Kansas Department of Agriculture
Division of Water Resources
CHANGE: P/D WORKSHEET

RE: Filed Office Application for Change
Water Right, File No. 3424, 6073 & 8059

CHANGE IN POINT OF DIVERSION WATER RIGHT, FILE NO. 3424; 6073 & 8059

RE: Application for Change in Point of Diversion
Water Right, File Nos. 3424, 6073 & 8059

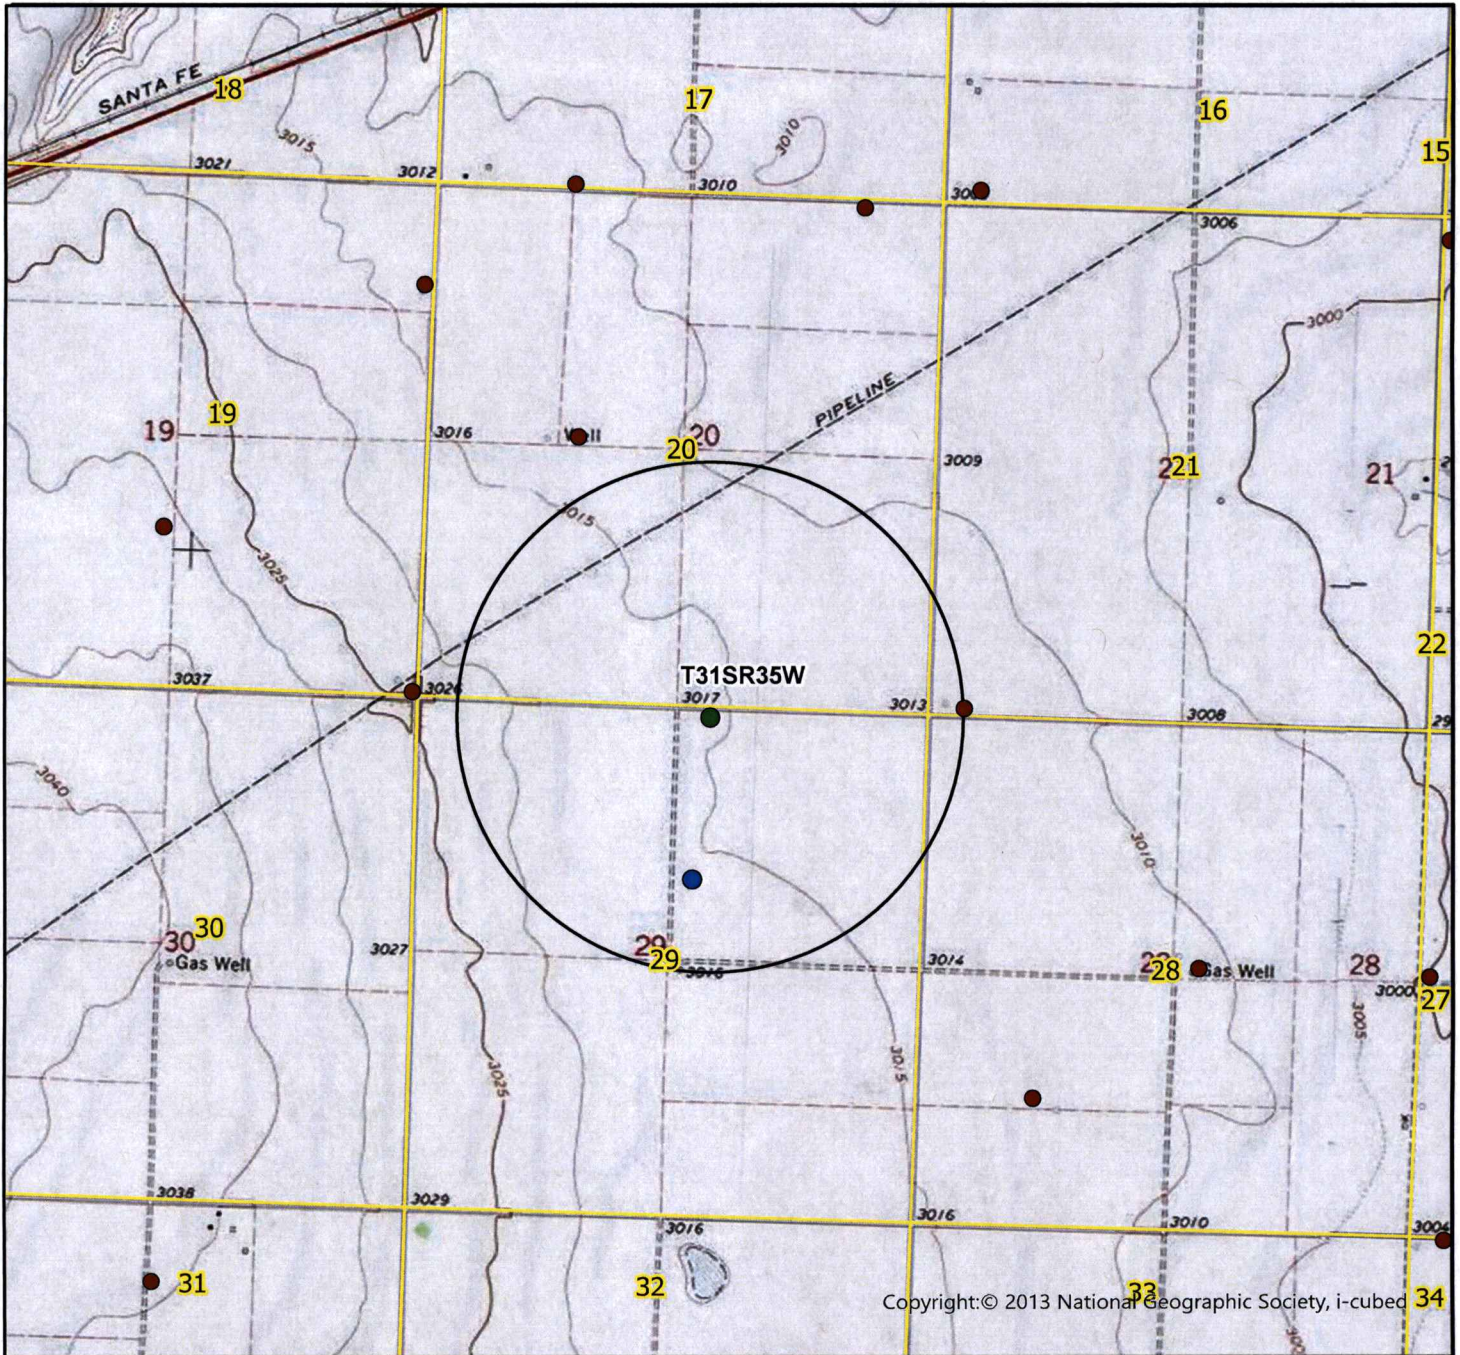
We have completed a review of the application for the above referenced water right. The proposed change in point of diversion is in accordance with current area rules, K.A.R. 5-23-3, as it pertains to minimum spacing to neighboring wells and distance moved.

Well evaluations were not conducted to estimate possible effects of the proposal on the supply of other wells with water rights prior to the proposal per K.S.A. 82a-708b, and the management program. In this case, the current point of diversion was approved in 2023 with little pumping in 2023. With such a short time at the current location there is no history to determine effects. Also the proposal is to revert back to the previous location, which would be moving back to recent historic effects in the area. So it was determined that the analysis was not needed in this case.

Therefore, GMD3 sees this move as meeting current area rules and would recommend approval. If aquifer conditions change or there is a change to the water right in the future, we would be happy to evaluate the effects at that time.

This proposed change will move the well back to the original location. Since the first app was just approved, no real pumping has accorded so the move back would not be adding any effects that have not already been there.

Is a waiver needed: Move is less than half mile. Minimum spacing to neighboring wells appears to be met.

Recommendation: After review of all available information, it appears current area rules are met. The analysis for this change was not done due to this is moving the authority back to the original location and has no real pumping history at the current location. Staff therefore recommends approval of the application.
